Packet Index and Revision Control

Six artifacts assembled from CAD, network, electrical, and RFI exports

RFI-214B Markup and Final Answer

RFI	Discipline	Opened	Answered	Status
214B	Access control / architectural	2026-06-09	2026-06-12	Issued Rev C

Network Topology N1.07

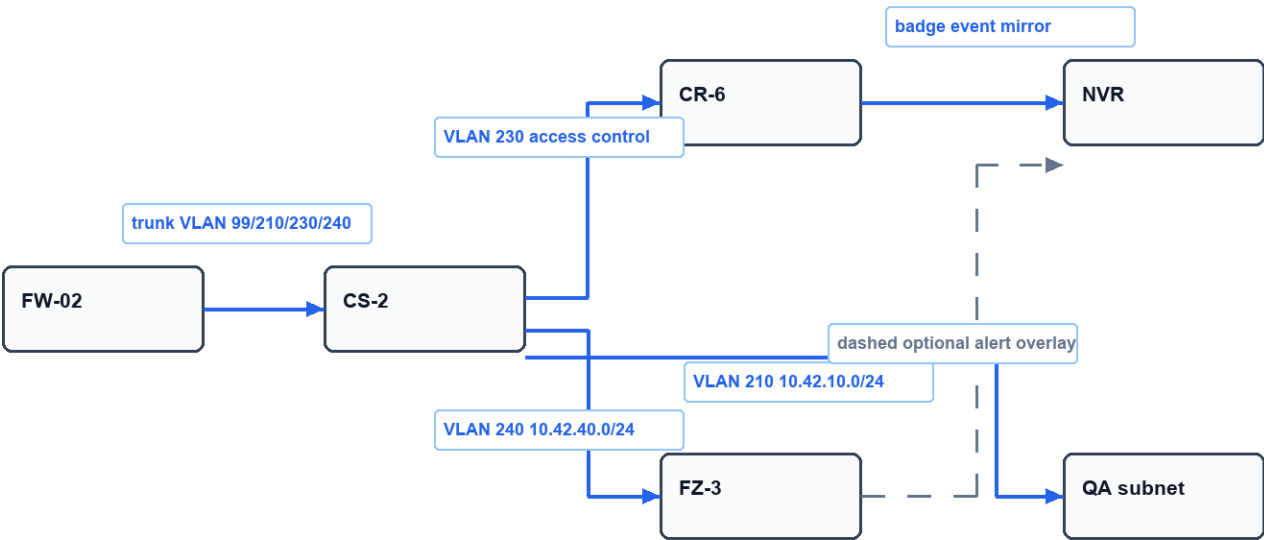
Subnet note

VLAN 240 maps to freezer and camera telemetry subnet 10.42.40.0/24. VLAN 230 is access control. VLAN 210 is QA devices.

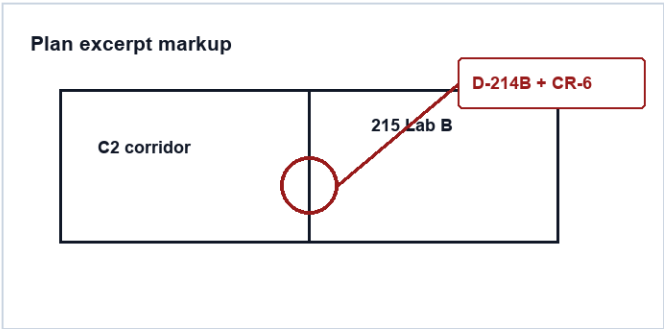
Question: Door label conflict. CAD Rev B shows D-214A at Lab B corridor. Field sticker and security rough-in show D-214B. Which label controls for access control schedule?

Response: Use D-214B for the Lab B corridor door. Add CR-6 card reader on corridor side. Update access control schedule and panel LP-2 circuit L2-15. Rev C dated 2026-06-12 controls.

Field	Rev B	Rev C final
Door label	D-214A	D-214B
Reader	none	CR-6 corridor side
Circuit	unassigned	L2-15
Schedule status	draft	issued
